SUNDRY NOTICES AND REPORTS ON WELLS

1. Type of Well <input type="checkbox"/> Oil Well <input checked="" type="checkbox"/> Gas Well <input type="checkbox"/> Other	8. Well Name and No. East Turkey Tract 3 Federal #1
2. Name of Operator Apache Corporation	9. API Well No. 30-015-34435
3a. Address 303 Veterans Airpark Ln, Midland, TX 79705	3b. Phone No. (include area code) 432-818-1106
4. Location of (Footage, Sec, T., R., or Survey Description) 1793' FNL & 1790' FWL, Sec 3, T19S, R30E	10. Field and Pool, or Exploratory Area Hackberry, Atoka, North (GAS)
	11. County or Parish, State Eddy Co., NM

Apache Corporation proposes to P&A the above mentioned well by the attached procedure.

* See Changes page 4 & 5

PROPOSED PROCEDURE

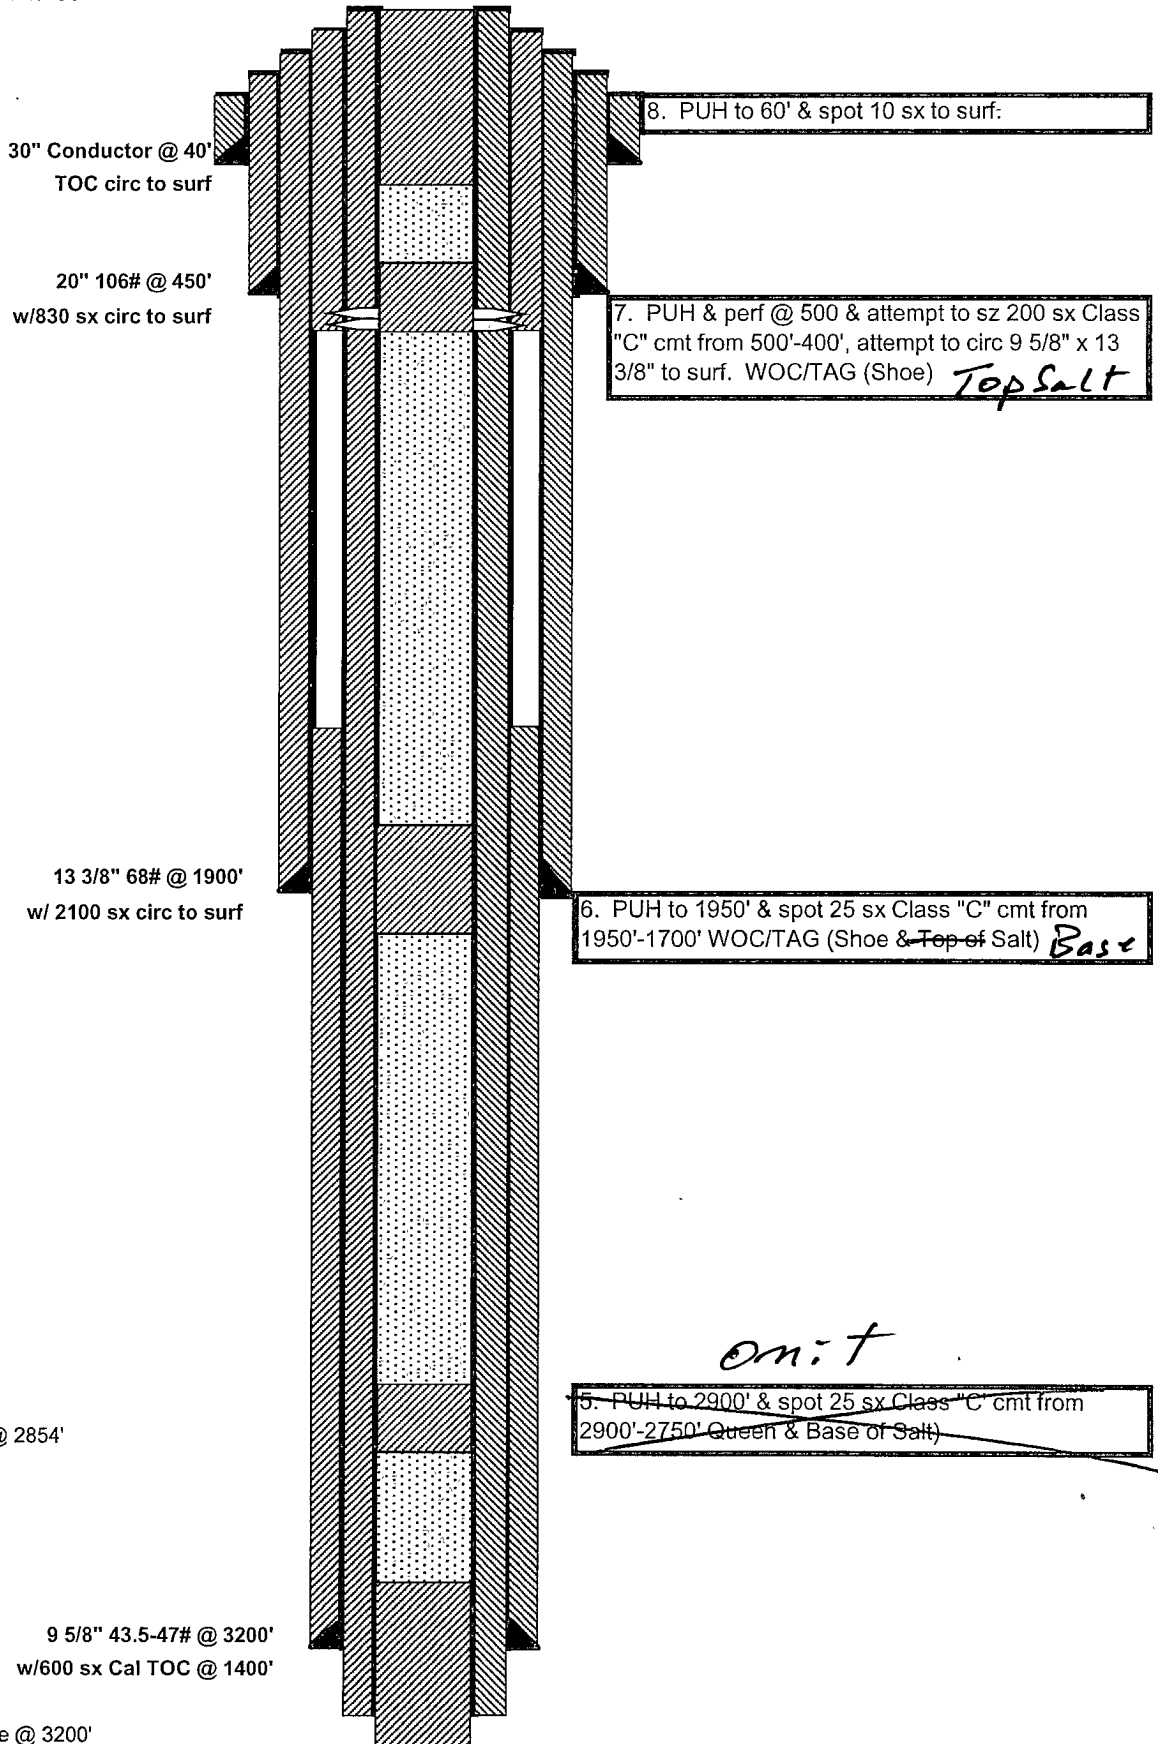
1. PUH to ~~3550'~~ & spot 25 sx Class "C" cmt from ~~3550'~~
~~3400'~~ WOC/TAG (San Andres, Delaware, & Shoe)

140' plug 3910-3770

2. PUH to ~~5850'~~ & spot 25 sx Class "C" cmt from ~~5850'~~
~~5600'~~ (Top of Bone Springs)

160' plug
5970-5810

3. Spacer Plug 7830-7650
Top 1st Bone Spring (180' plug)
No Tag

2. PUH to ~~9650'~~ & spot 35 sx Class "H" cmt from ~~9650'~~
~~9300'~~ WOC/TAG (Wolfcamp & Bone Springs)

200'
9905-9705
